Inclined Ladder-Chain Arrgt

NSWCCD-SSES Code 974

Chain Arrangement

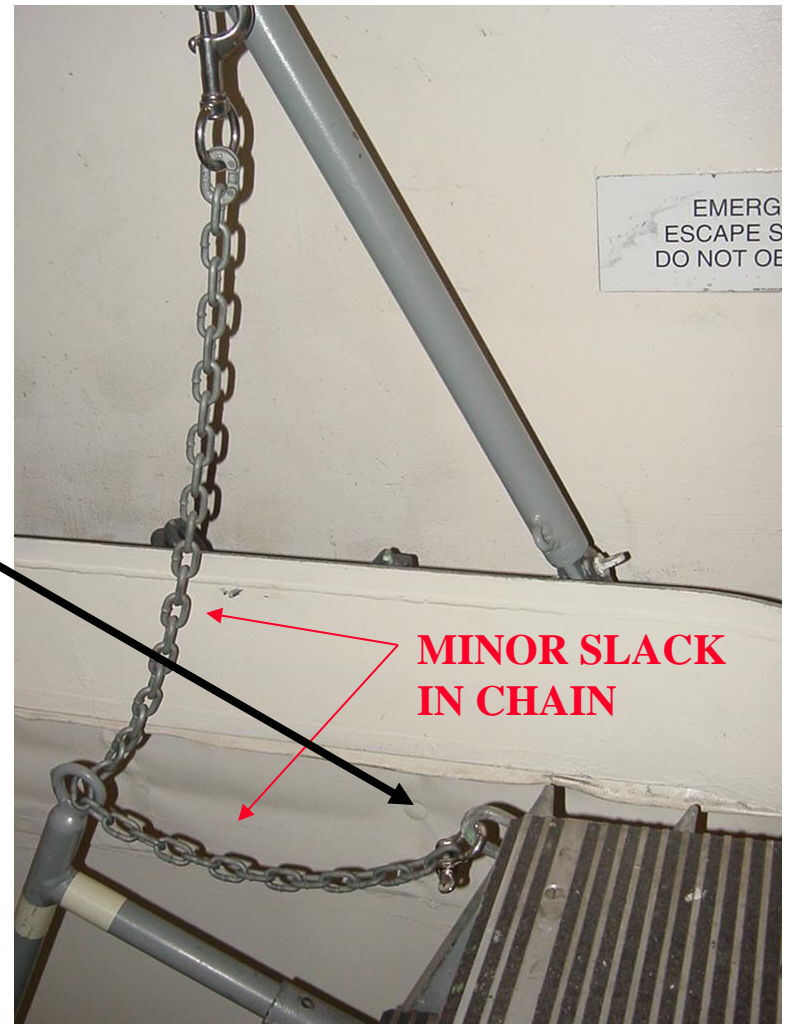
- Correct chain arrangement except for chain slack. Chain should be taut as possible.
- NAVSEA TYPE Dwgs S1604-860040 (Steel) & 804-1749113 (Alum) show correct chain hand grab arrangement for inclined ladders.

This shackle can be used to tighten up the chain by inserting the shackle pin in different links and letting the excess chain hang down.
